GE Nuclear Energy

Subject: License Amendment Request (Revision #46)

Reference: SNM Material License SNM-1097, Docket # 70-1113

LICENSE SNM-1097 DATE 02/04/94
 DOCKET 70-1113 REVISION 46

FIGURE 5.5

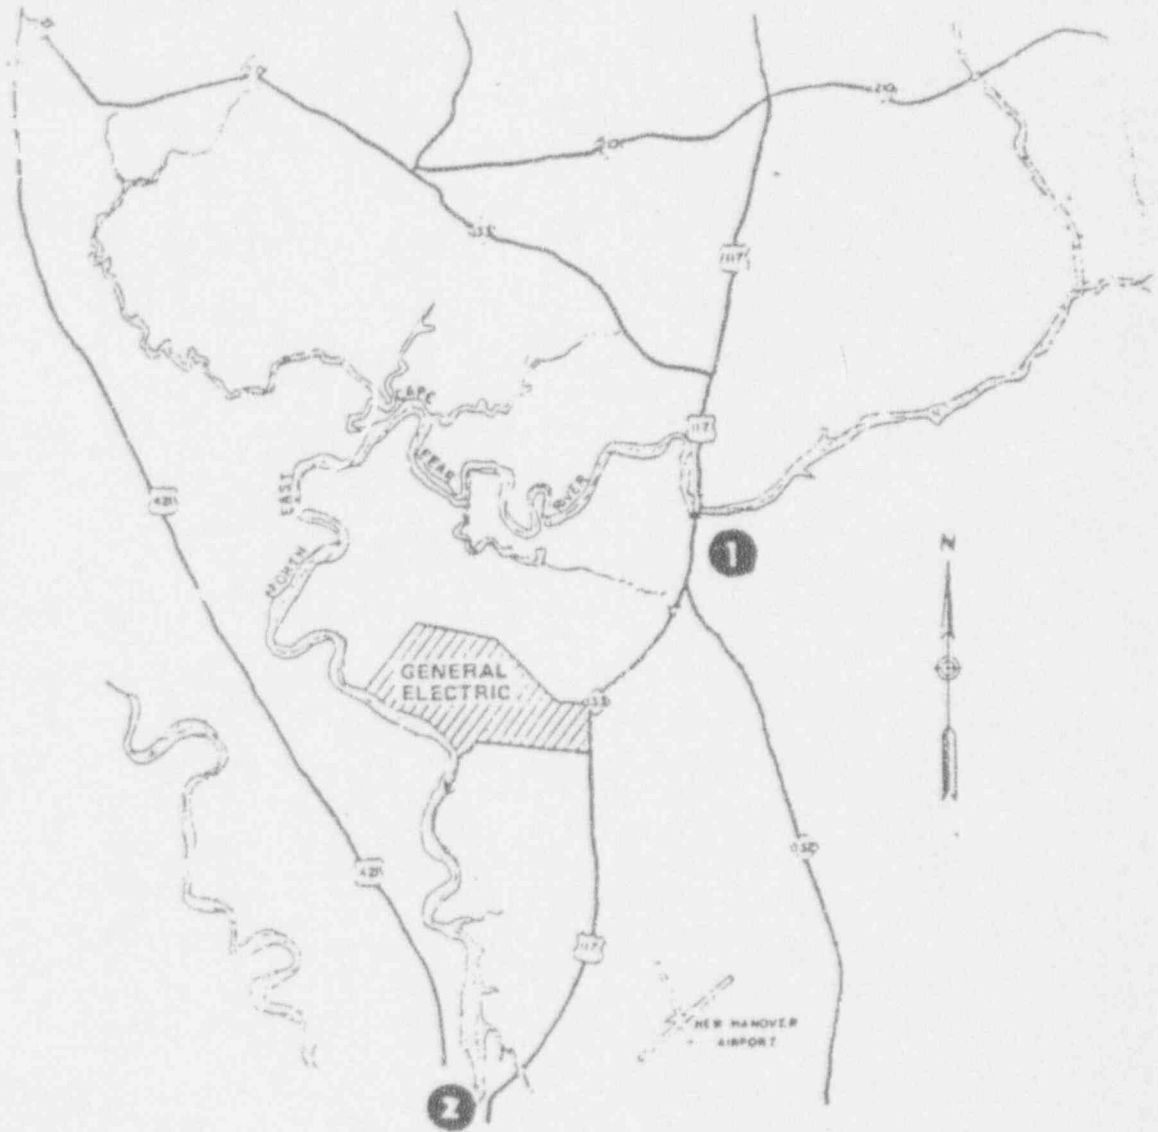
<u>Existing Page(s)</u>	<u>Section</u>	<u>Explanation</u>
I-5.25	Figure 5.5	An inconsistency between Table 5.1 and Figure 5.5 was corrected by changing the sample frequency on Figure 5.5 to monthly.
I-5.26	5.2.3.1	The action level was lowered to reflect 10 CFR 20 revision (see Table 5.1).

Location	Sample Type	Frequency	
#1 - Upstream Public Boat Dock	Grab	Monthly	*
#2 - Downstream Seaboard Coastline Railroad Bridge	Grab	Monthly	*
